**RE: POWERHOUSE ULTIMO REVITALISATION – SSD 67588459
MODIFICATION 1 – RESPONSE TO SUBMISSIONS (HERITAGE)**

This addendum to the Heritage Impact Statement (HIS) has been prepared to provide a response to heritage matters raised during the public exhibition of Modification 1 of SSD-67588459 for the Powerhouse Revitalisation Ultimo (PUR) project. In response to the submissions a number of minor changes have been proposed to the scheme, these changes have been described below and have been assessed for potential heritage impact.

Figure 4 - Proposed location of high-level glazing as part of the approved external and internal cladding. (Source: DBJ Architects)

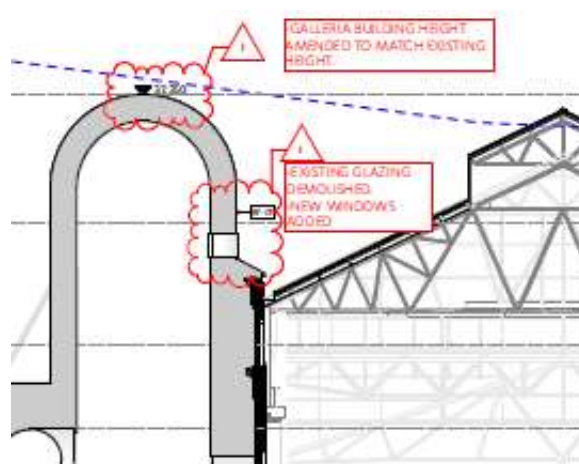
CoS5 Additionally, the Archaeological Assessment identifies the Powerhouse Ultimo site to have moderate to high potential to contain archaeological evidence related to this historical phase of use. This should address the increased excavation associated with the removal of the existing structures. The retention or reconstruction of the Galleria and glazing should also be considered. The existing glazing provides a lighter and more spatial experience within the Galleria.

CoS6 The proposed replacement glazing is smaller in area and would result in a 'heavier and darker' experience. The glazing line would also provide maintain a clear visual break between the structures, delineating the existing heritage buildings and new building.

HC4 Recommends that the high-level glazing to the eastern side of the Galleria, including the lower raked section that connects to the adjacent building, be replaced with new continuous glazing in keeping with the original design. It is considered that the proposed use of opaque cladding, particularly to replace the lower raked glazing, would have an adverse heritage impact.

CoS5 *The retention or reconstruction of the Galleria and glazing should also be considered. The existing glazing provides a lighter and more spatial experience within the Galleria.*

CoS6 *The glazing line would also provide maintain a clear visual break between the structures, delineating the existing heritage buildings and new buildings*

HC4 *Recommends that the high-level glazing to the eastern side of the Galleria, including the lower raked section that connects to the adjacent building, be replaced with new continuous glazing in keeping with the original design.*

The Modification proposes the replacement of the existing linear window with a series of high-level windows that sit above a new junction flashing detail, set well above the upper edge of the box gutter. The composition of the proposed high-level windows is an integral part of the character of the contemporary interior design of the Galleria space. These windows are not visible from the public domain, and their contribution is limited to the internal character of the space.

The spatial volume of the Galleria will be conserved in the approved design, with a contemporary fitout and character. The proposed glazed openings have been designed to respond to a desired internal experience, in line with the approved proposal.

Whilst the original design provided a clear distinction between the existing and new buildings at high level, the approved design provides an alternative approach to making a demarcation between the Galleria and the Engine House and Turbine Hall. The visual relationship between the two buildings remains, with discrete views of the eastern elevation of the Engine House and Turbine Hall forming an integral part of the backdrop to the Galleria space, however rather than the two buildings reading as 'separated' the Engine House and Turbine Hall walls read 'through' the new lining of the space. The insertion of a high-level line of glazing introduces an incompatible element to the approved design concept and potentially compromises the contemporary concept for the museum space.

As noted, the original design of the glazed junction between the new and historic buildings created a box gutter which has led to ongoing maintenance issues. It is not considered an appropriate response, nor good heritage practice, to reconstruct an original design if it leads to ongoing damage.

The proposed change to the continuous glazing does not alter the form or appreciation of the Wran Building, and as such does not alter the significance of the building, nor its contribution to the wider Powerhouse precinct. For this reason, there are no adverse heritage impacts on the significance of the Wran Building, nor the wider Powerhouse site, arising from the change to the high level glazing design.

The removal of the original box gutter detail and its replacement with a more effective flashing and gutter detail is considered a positive heritage impact in terms of conservation of historic fabric.

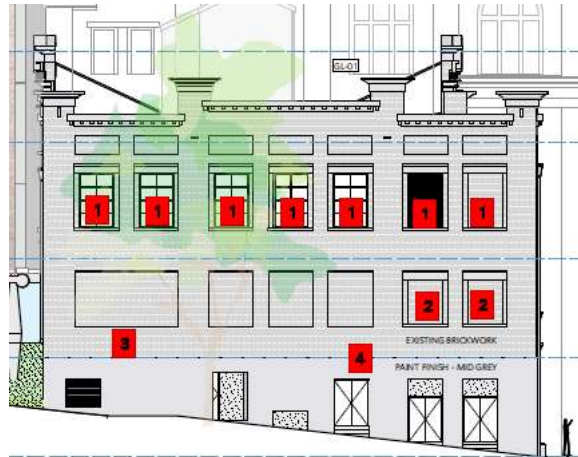
HC8 Recommends that changes to the ground floor openings on the east elevation of the Switch House be detailed so that the size and proportions of the original openings remain legible and any new fabric be discernible as introduced (non-original) fabric.

Further detailed design refinement will address the HC8 recommendation that the openings be detailed so that the size and proportions of the original openings remain legible and that new fabric be recognised as such. This approach is in line with best heritage practice as set out in *The Burra Charter: The Australia ICOMOS Charter for Places of Cultural Significance, 2013*, specifically Article 22. New Work

The following tables identify each of the proposed changes to the Switch House elevations more clearly, noting also the existing and approved conditions as well as the proposed heritage impact of each change.
